Access Compliance Report

Public Rights-of-Way

Intersection ID: 25211	Main Street: SMITH_RD	Cross Street: SOUTHBRIDGE_FOREST_DR	Location: SE
ADA ID: C2F05F0EB45F	Ramp Type: Perp	Initial Pass/Fail: Fail	Overall Compliance: No
		Severity Score: 12.5

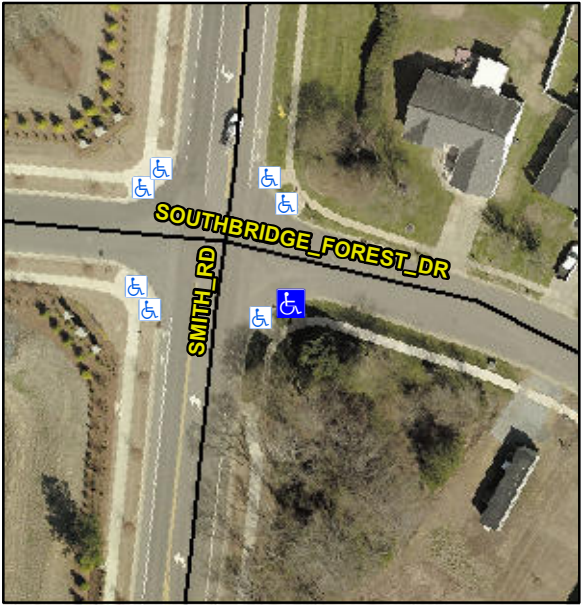
Codes/Mitigation Info/Possible Solution		Field Measurements/Component Compliance			
	Possible Solutions:				
	Remove & Replace Entire Ramp.				
	Surveyor Notes:				
	N/A				
	PROW/ADA:				
	R304.2.2				
Street 1 Name	SOUTHBRIDGE FOREST DR				
Stop Condition-Street 2	StopSign				
Street 2 Name	N/A				
Stop Condition-Street 1	N/A				
Total Cost:		\$	1850.00

Compliance	Description	Data	Compliance	Description	Data
N/A	Ramp Length (in)	116.0	No	Ramp Slope (%)	8.6
Yes	Ramp Width (in)	92.0	Yes	Ramp XSlope (%)	0.4
N/A	Flare Type LT	N/A	N/A	Flare Type RT	N/A
N/A	Flare Slope LT (%)	N/A	N/A	Flare Slope RT (%)	N/A
N/A	Flare Traversable LT?	N/A	N/A	Flare Traversable RT?	N/A
N/A	Landing Length (in)	N/A	N/A	DWS Provided?	N/A
N/A	Landing Width (in)	N/A	N/A	DWS Contrast?	N/A
N/A	Landing Slope (%)	N/A	N/A	DWS Length (in)	N/A
N/A	Landing X Slope (%)	N/A	N/A	DWS Full Width?	N/A
N/A	Landing Curb? (Y/N)	N/A	N/A	DWS Offset (in)	N/A
N/A	Shared Landing?	N/A			
N/A	Gutter Ponding?	N/A	N/A	Gutter Slope (%)	N/A
N/A	Gutter Lip Ht (in)	N/A	N/A	Gutter X Slope (%)	N/A
N/A	Painted X Walk1?	No	N/A	Painted X Walk2?	N/A
	X Walk 1 Direction	To NE		X Walk 2 Direction	N/A
N/A	X Walk 1 Width (in)	N/A	N/A	X Walk 2 Width (in)	N/A
	X Walk 1 Slope (%)	0.5		X Walk 2 Slope (%)	N/A
	X Walk 1 X Slope (%)	1.1		X Walk 2 X Slope (%)	N/A
